August 1, 2014

RE: Hudson Property Mitigation Plan Comments
Contract # 004638
EEP IMS # 95361

POINT-BY-POINT RESPONSE:

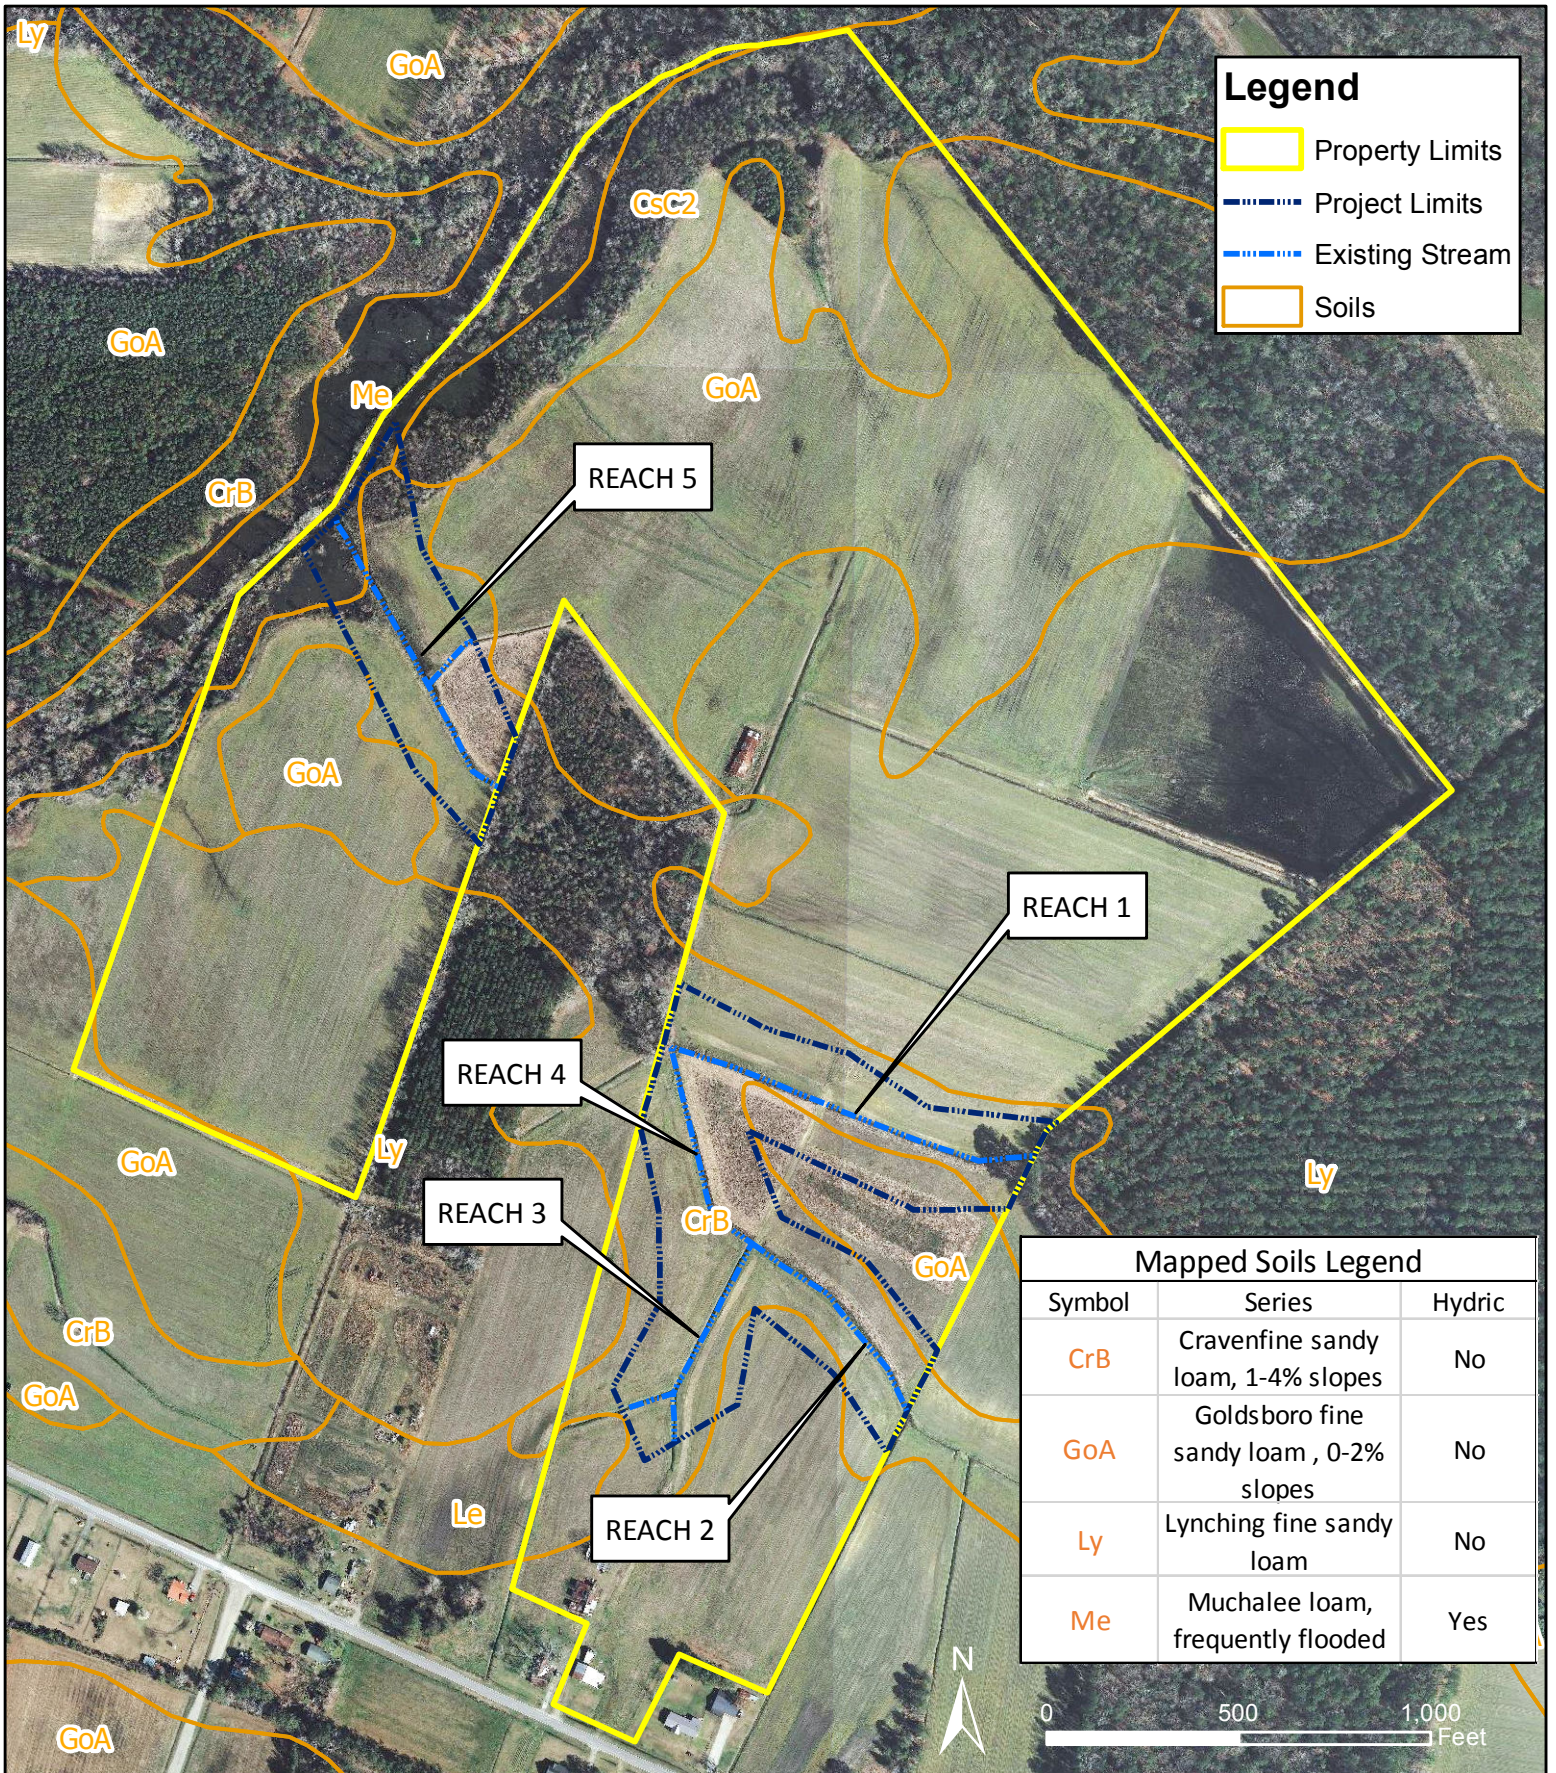
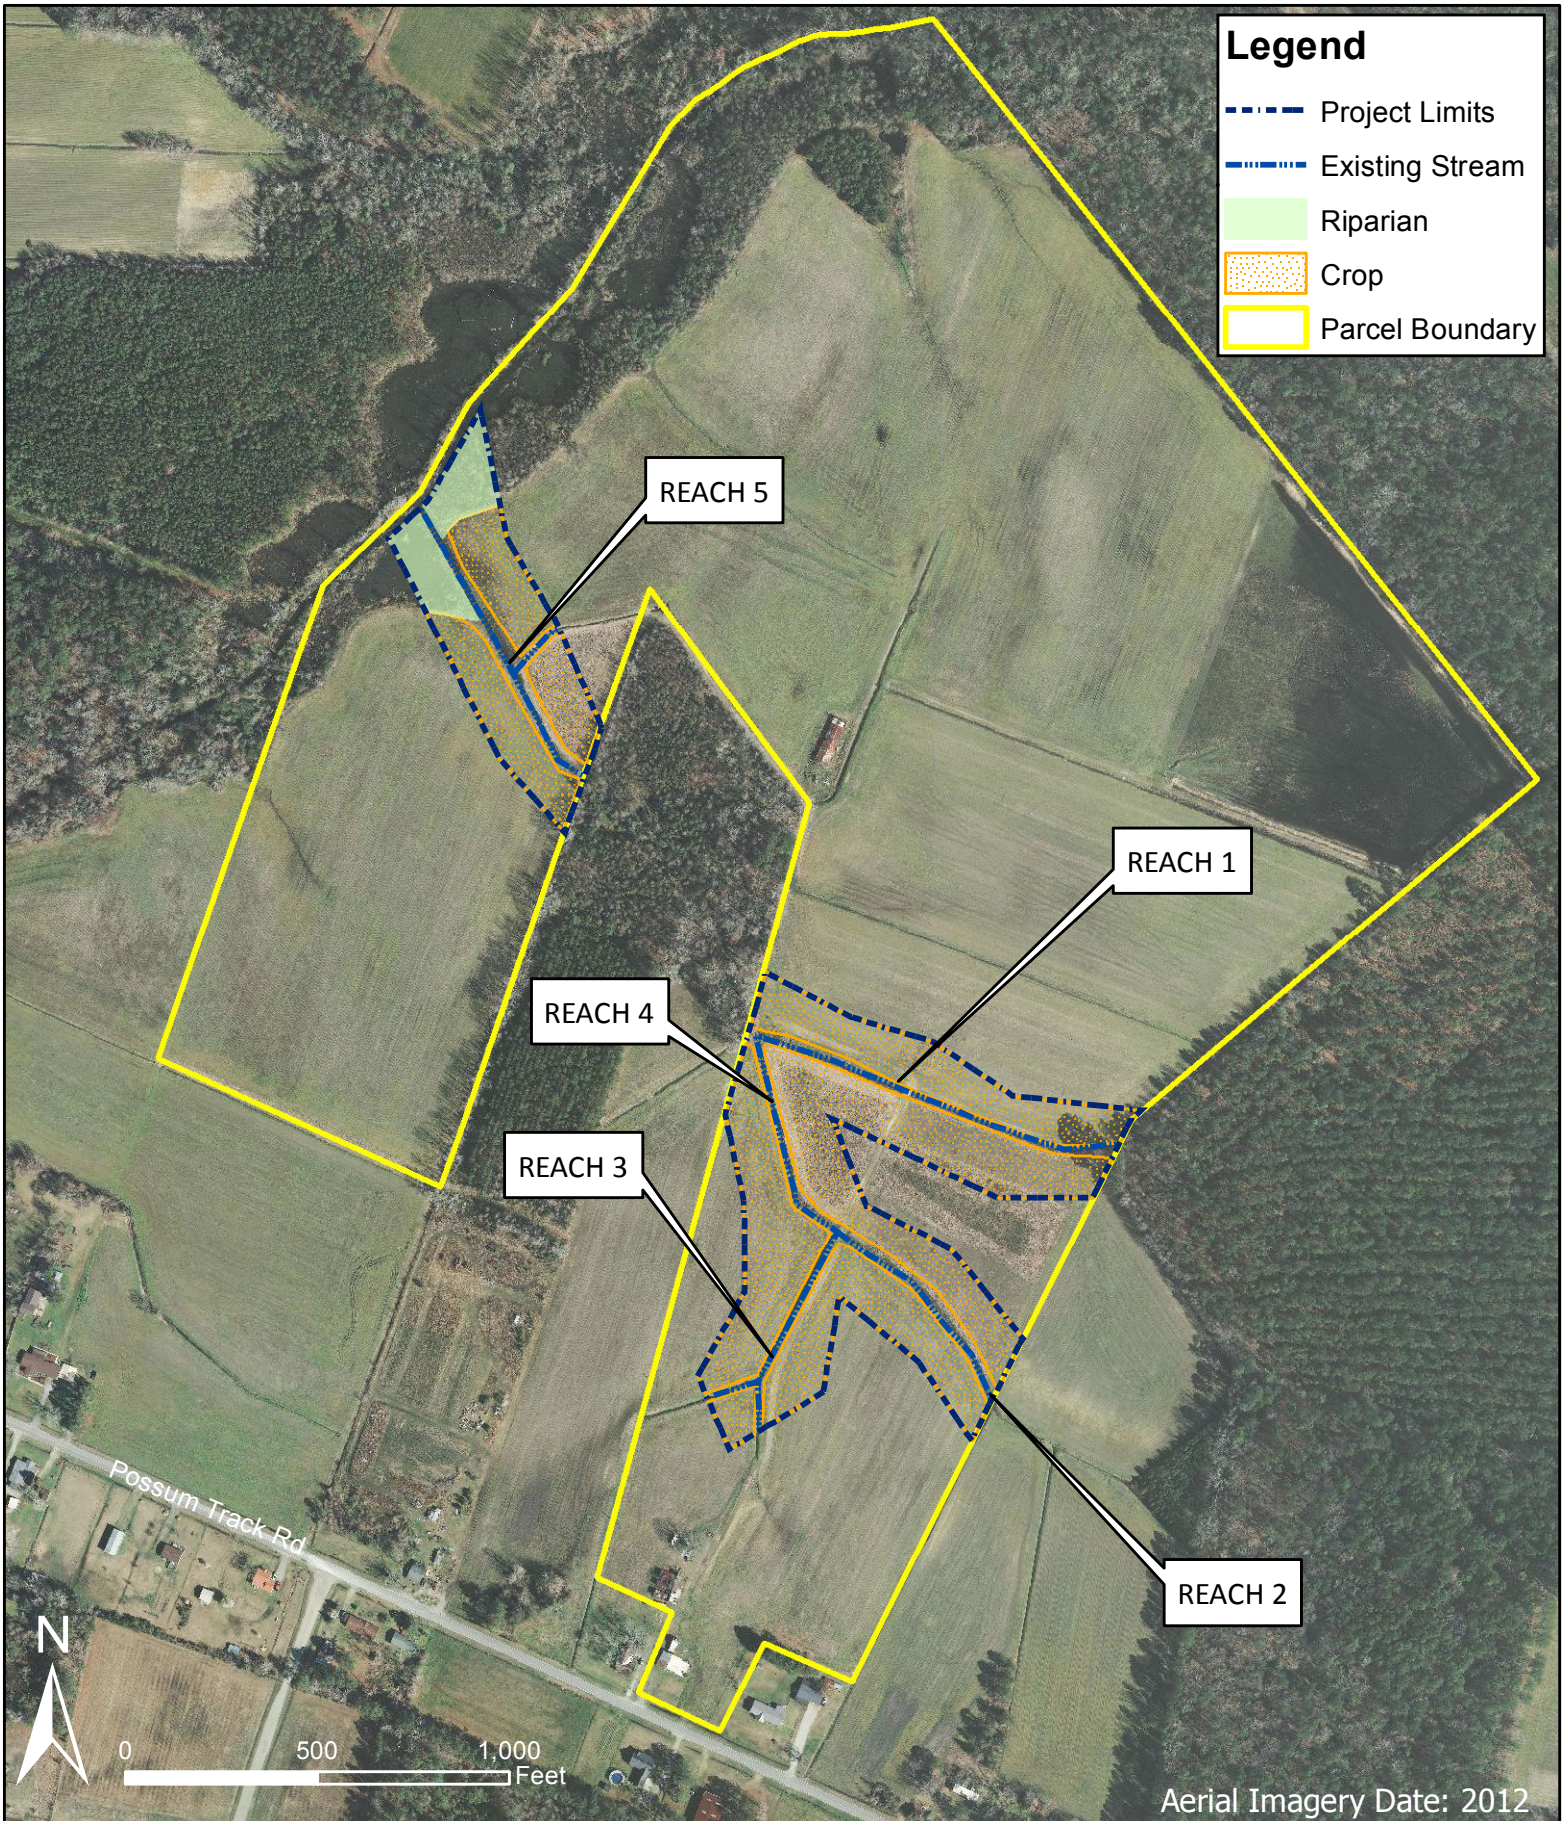
- Exhibits C-K do not denote the Reaches 1-5 on the map. No diagram of the Reaches was illustrated until the appendices. Recommend mapping these within the main body of the MP for clarity.

Exhibits C, D, H, and K (immediately following the mitigation report) were revised to denote Reaches 1-5.
